# CITY OF QUINCY

**Subject: Addendum No. 1 to the South Quincy Lift Station Rehabilitation Project**

SOUTH QUINCY LIFT STATION  
REHABILITATION  
CITY OF QUINCY  
730 MAINE STREET  
QUINCY, ILLINOIS

ROOF DETAILS

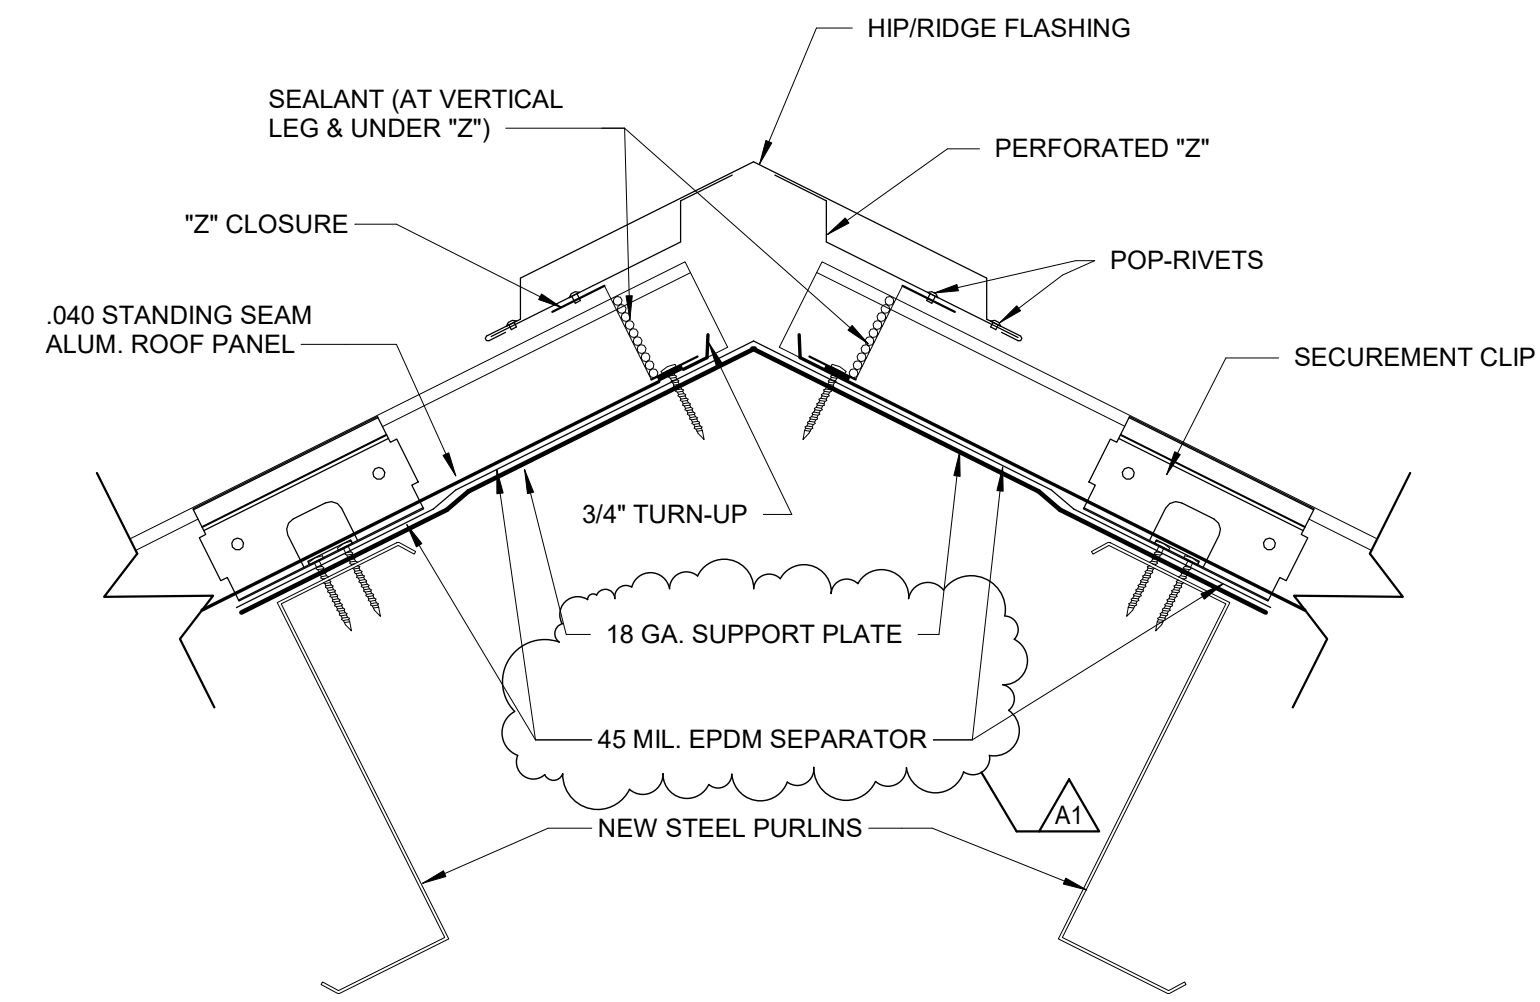
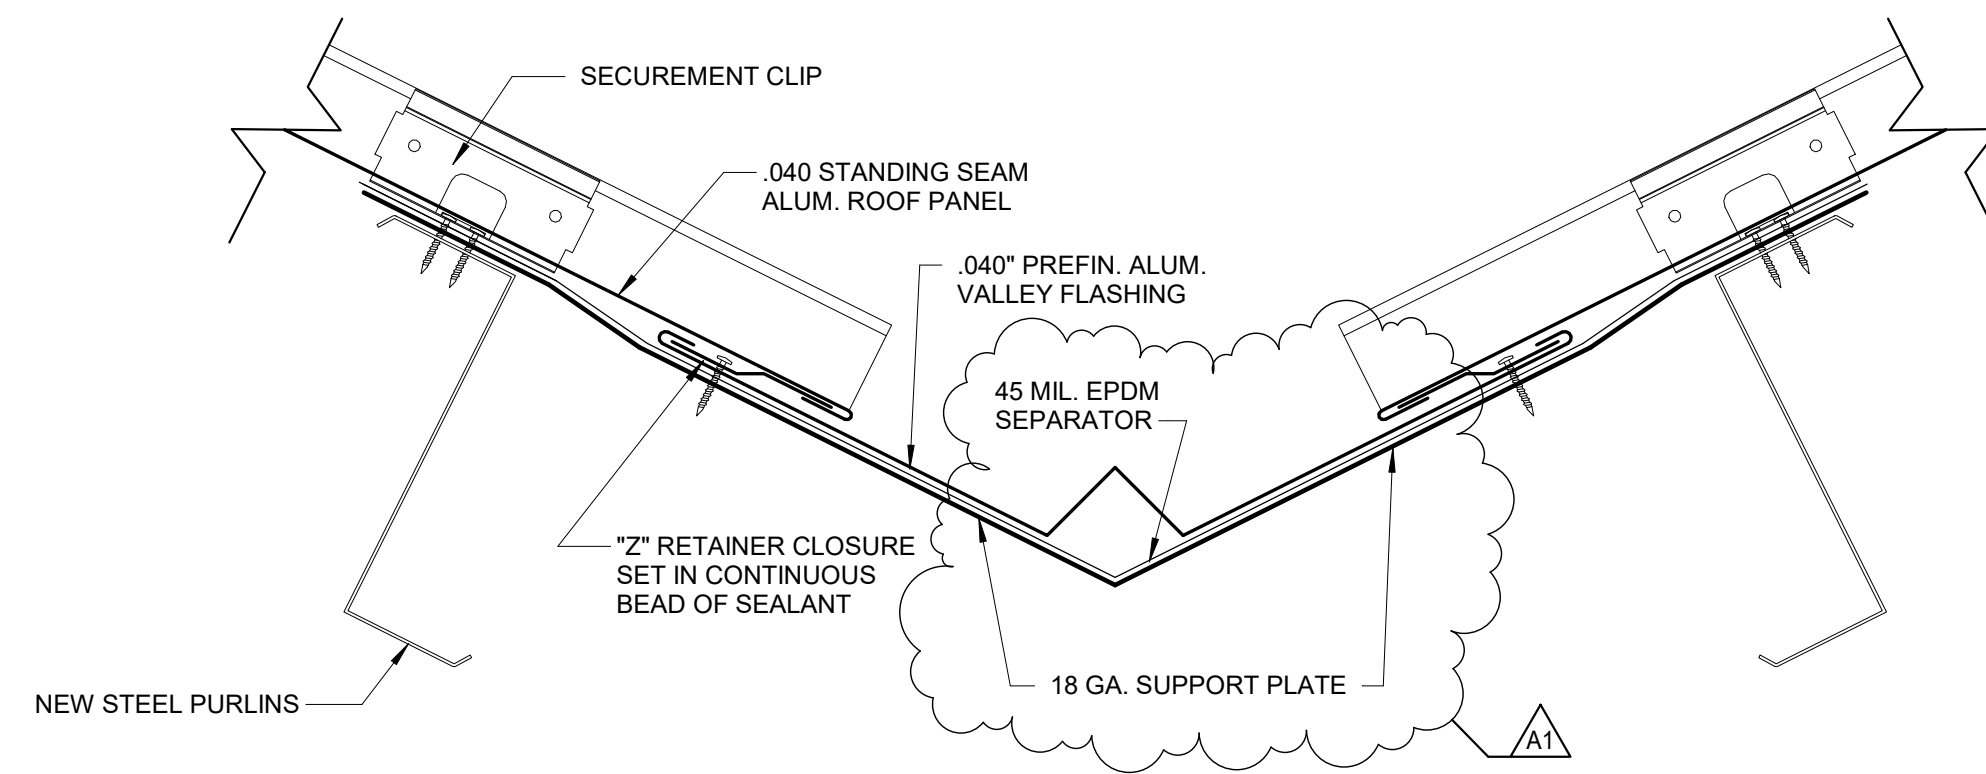
1. Sheet A102 is revised, a copy of which is enclosed.
2. Sheet E501 is revised, a copy of which is enclosed.
3. Section 26 32 13, paragraph 2.2 insert the following revision:
